Product Change Notification

106709 - 02

Change Notification #: 106709 - 02
Change Title: Intel NetStructure(R) MPCMM0002Q Chassis Management Module, PCN 106709-02, Product Design, changes to faceplate, front panel LED, EMI filter, ejector handle, new firmware, changes to faceplate, front panel LED, EMI filter, PCB layout, capacitors 16V and 100V, RJ45 connector, substituted RoHS label, Reason for Revision: Label change, additional details on faceplate changes, Safety Note
Date of Publication: July 27, 2007

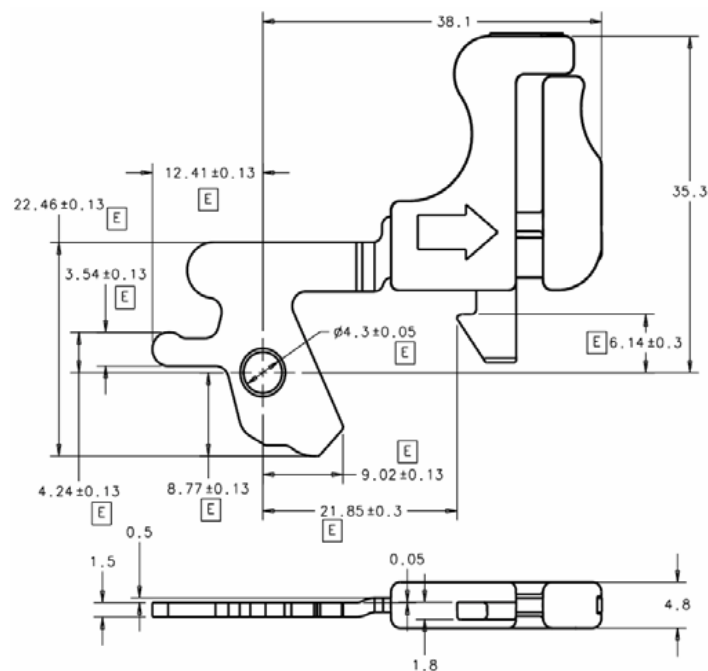
1. Following changes were made to the faceplate to accommodate new ejector handle and changes to DSUB15 connector for telecom alarm:
 - a. Added hex slot to DSUB15 connector
 - b. Added chamfer to accommodate new ejector handle
 - c. Changed guide pin to resolve deformation of front panel
 - d. Changed thumb screw size to use standard AdvancedTCA thumb screw.
 - e. Changed faceplate overlay to accommodate new thumb screw and new ejector handle.
 - f. Removed spring washer as not needed for new ejector handle.

3. Removed EMI filter from DSUB15 connector and implemented filter cap.
4. Optimized component locations on board for yield improvements.
5. Changed ejector handle to improve ease of operation and reliability. New ejector handle drawing is shown below.
